SUBMISSION OF KATE WILSON

If I look at the first design plan:

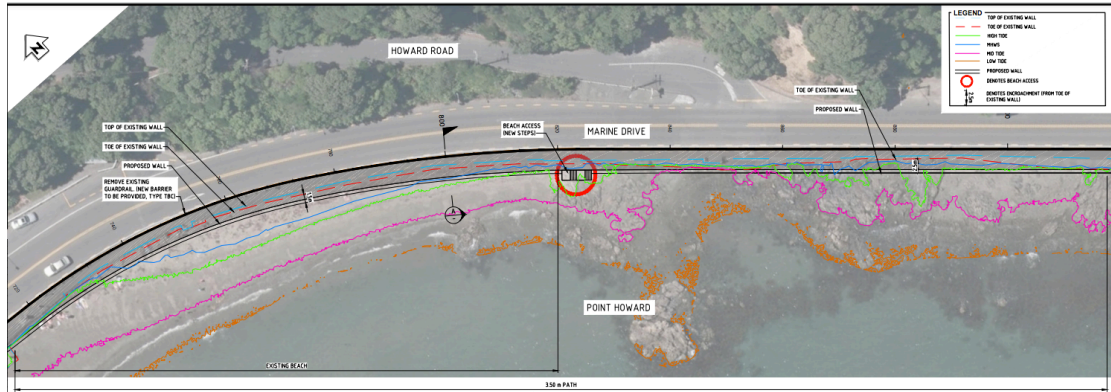
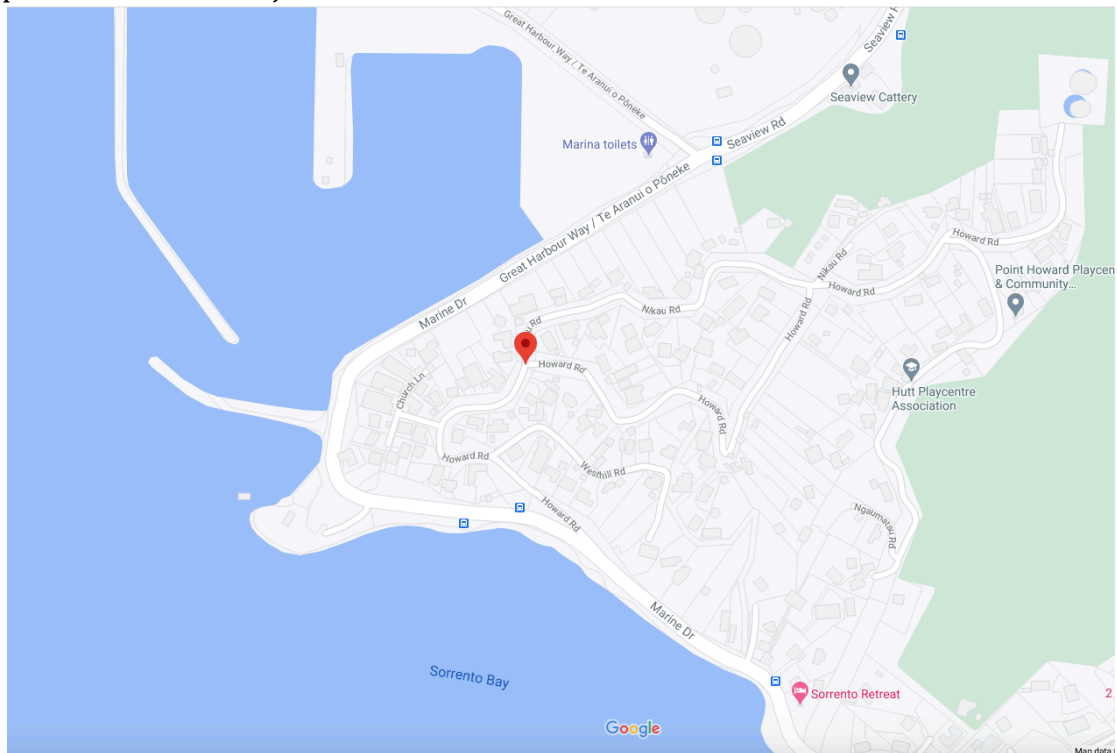
In the area to the left where the path crosses the access to the wharf there is a discontinuance of the trail prioritising, I presume, the access to the wharf business. This is not safe nor does it recognize a similar priority the person commuting by bike or walking would be given if they were in a car. Why? Why can we not message that priority, if given to the purpose rather than the mode, and with all respect there is plenty of room for a give way for even a long truck to be designed into this area, and they are invariably in a better position to address the potential conflicts of a crossing. Signage is required here to moderate vehicles crossing the path and coloured concrete or surface treatment that clearly shows that a shared path is crossing. I note you will be hearing from the energy company representative – I wonder at their conflict of not seeking a priority turn for trucks over the generally petrol fueled vehicles on the road at this point, yet they suggest they should get priority for walkers and bikers. We should be discussing people, not the mode. If priority is to be given to commuters, then the shared path users should be given priority. Anything else will not address the 60% interested but concerned potential cycle users.

To the right I note one of the very few pedestrian crossings along the whole route that connects the residential area to the trail. Yet it appears to be at a point where the trail is at its narrowest, on a bend and also where there is an access

point to the beach – which makes me wonder about people crossing with paddle boards, kayaks or prams. While those crossing are given priority over the road, the conflict with path users has to be addressed in the planning – and with consistency.
